Agenda
Village of Arlington Heights
Design Commission
Community Room, 3rd Floor

Arlington Heights Village Hall
33 S. Arlington Heights Road
Arlington Heights, IL 60005
March 13, 2018
6:30 PM

MINUTES OF
THE VILLAGE OF ARLINGTON HEIGHTS
DESIGN COMMISSION MEETING
HELD AT THE ARLINGTON HEIGHTS MUNICIPAL BUILDING
33 S. ARLINGTON HEIGHTS RD.
FEBRUARY 27, 2018

FRONT ELEVATION
(1/4" = 1'-0")

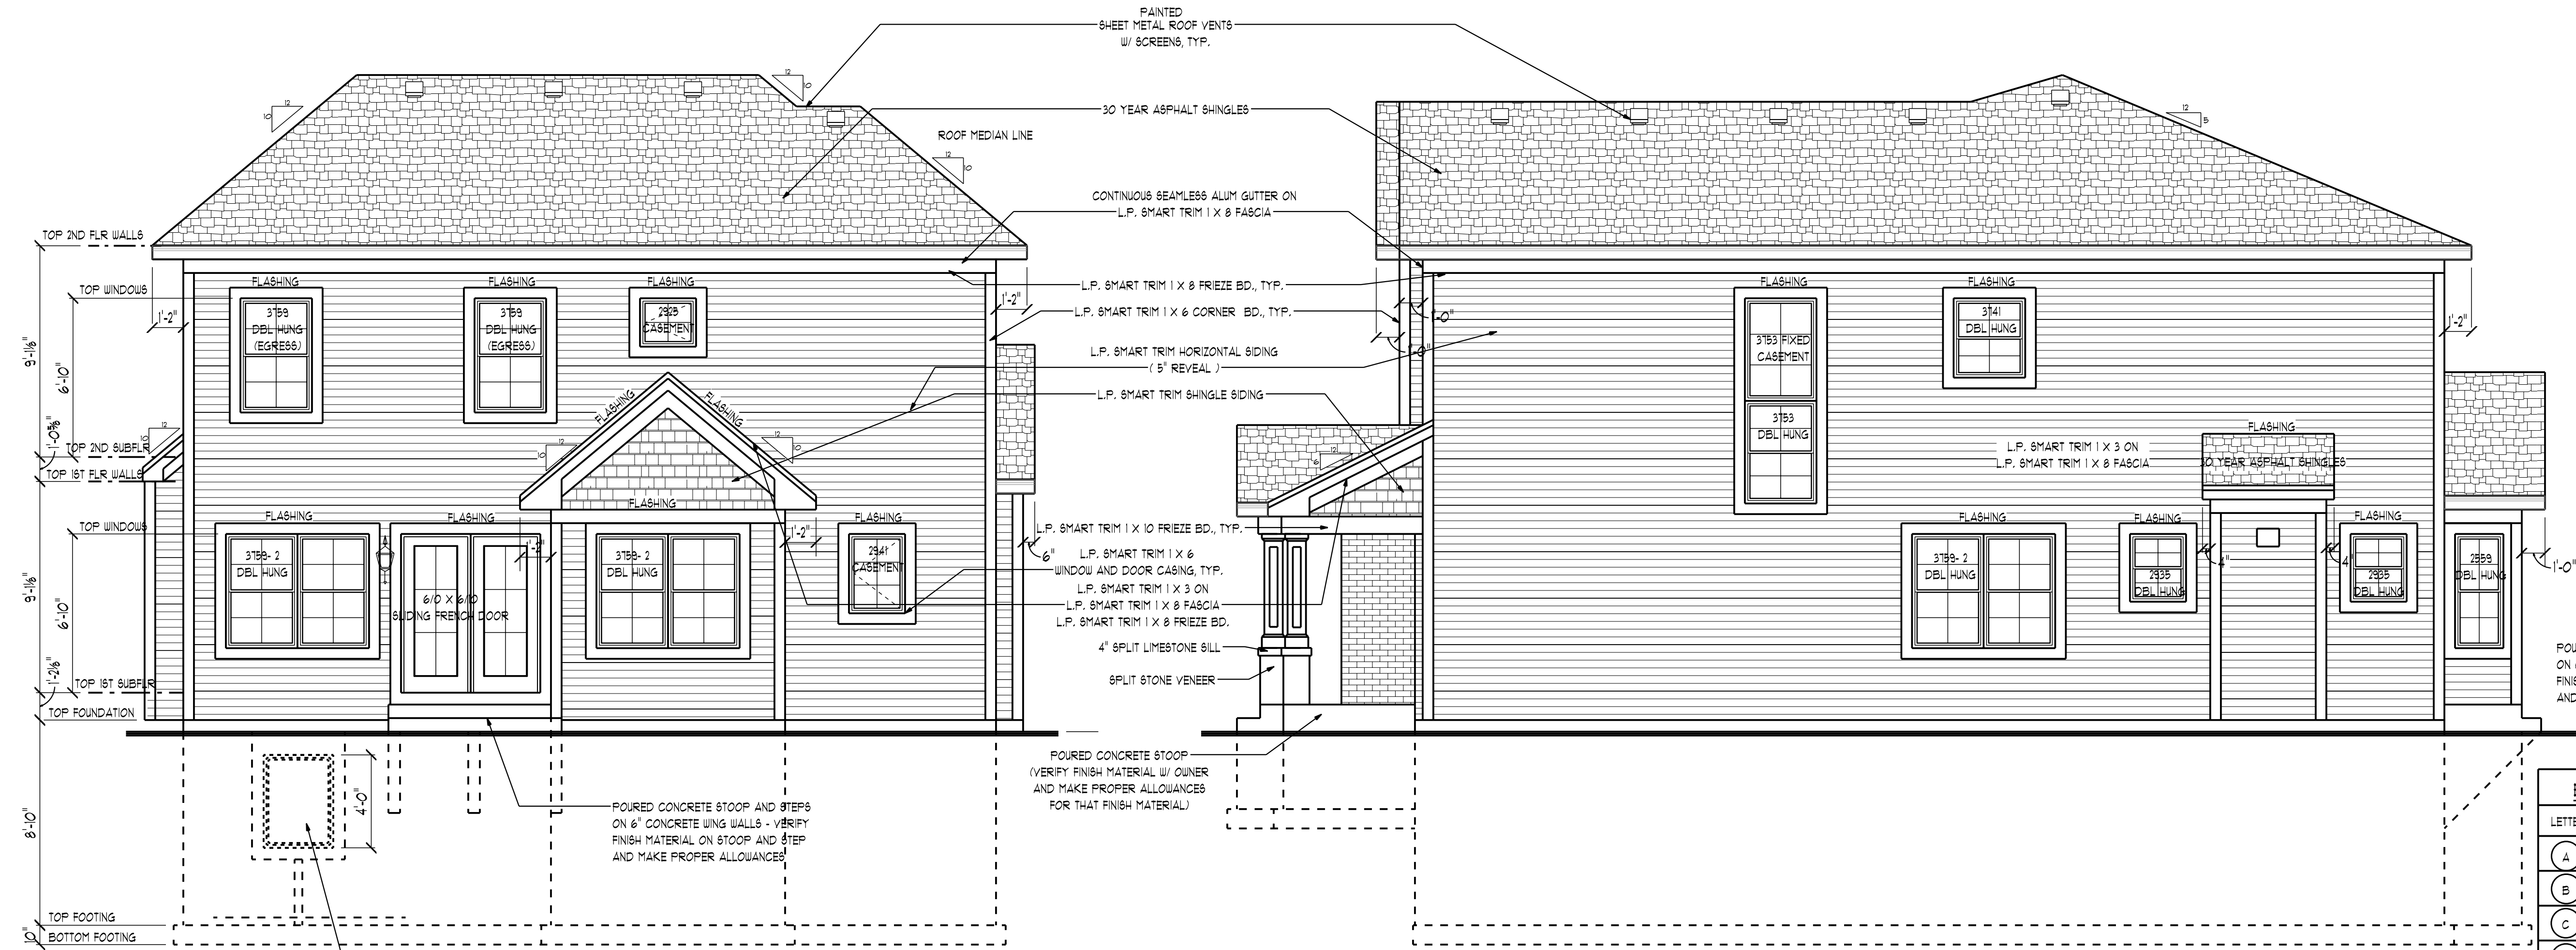
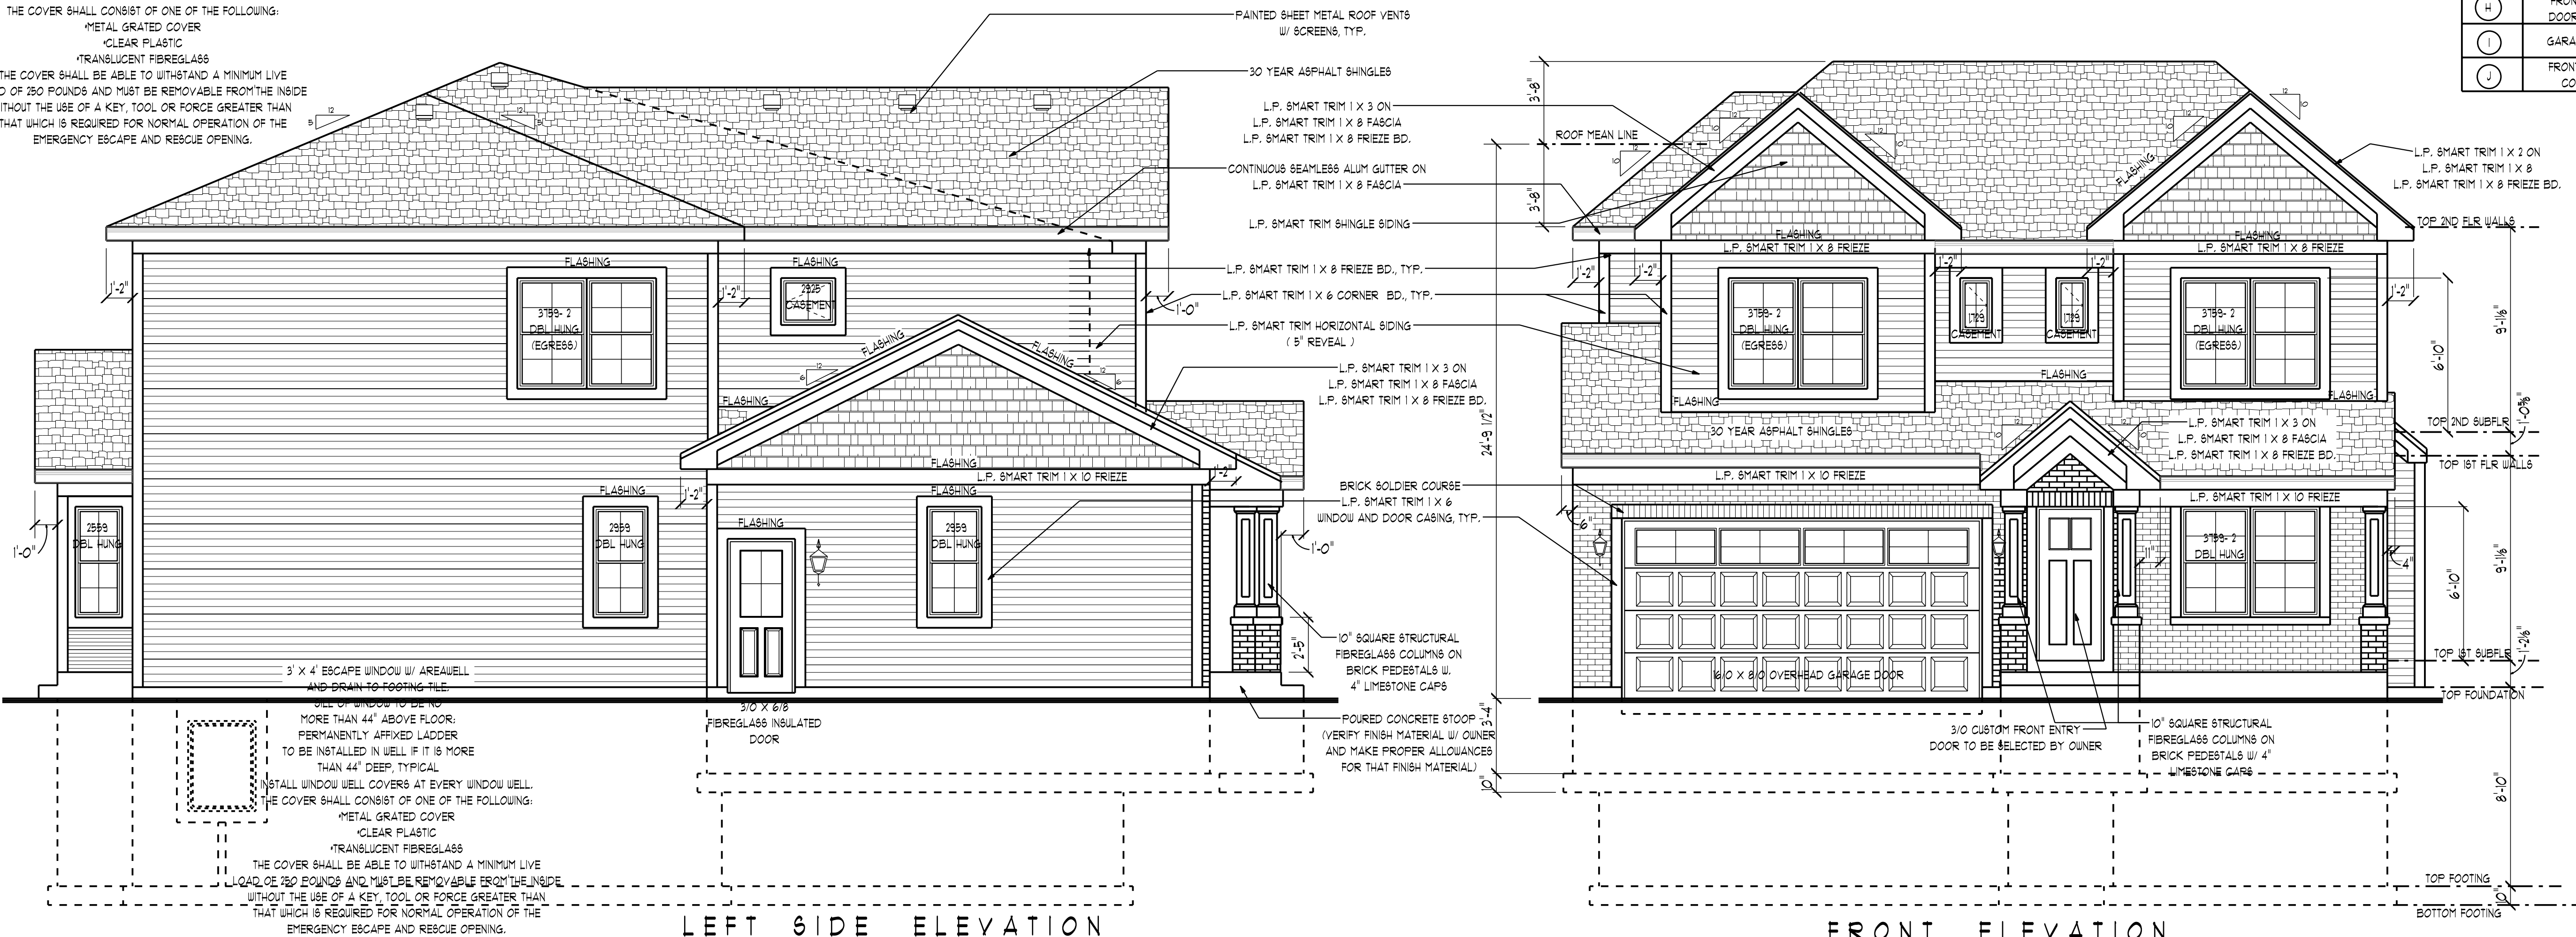
In response to the comments from February 27, the petitioner has made changes to the design as follows:

It is recommended that the Design Commission approve the proposed new single-family residence to be located at 407 E. Mayfair Road. This recommendation is subject to compliance with the revised architectural plans dated and received 3/5/18, and the following:
